# SERVICE INSTRUCTION SK-SI009 Rev NC Page 1 of 6

**SUBJECT:** *AUDIO PANEL UNMUTED INPUT*

**MODELS AFFECTED:** *CCK-1865, CCX-1865, CCK-2000 AND CCX-2000, WITH GMA 245R AUDIO PANEL.*

Figure 7: Rear Connectors J2401 & 2402, Viewed from Back of Unit

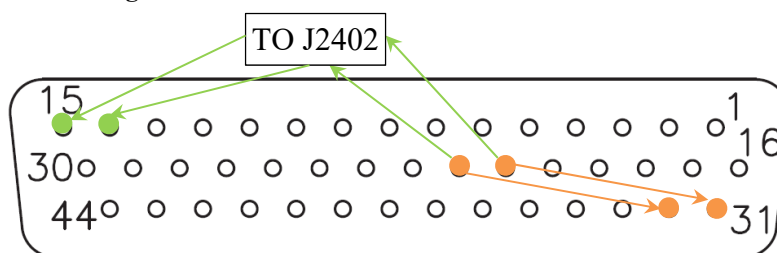
16. Refer to Figure 7, move pin from P2401 position 21 to 31 (orange).
  - a. If position 31 is already occupied, move to **P2402** position 15 (green).
17. Refer to Figure 7, move pin from P2401 position 22 to 32 (orange).
  - a. If position 32 is already occupied, move to **P2402** position 14 (green).
18. Close up and reconnect P2401, and if used, P2402.
19. Perform Step 2.
20. Accomplish Steps 9 through 11 to ensure audio is audible.
  - a. Emphasizing step 9, AUX 1 audio remains de-selected.
21. Make logbook entry stating that SK-SI009 Rev NC audio reconfiguration was accomplished.
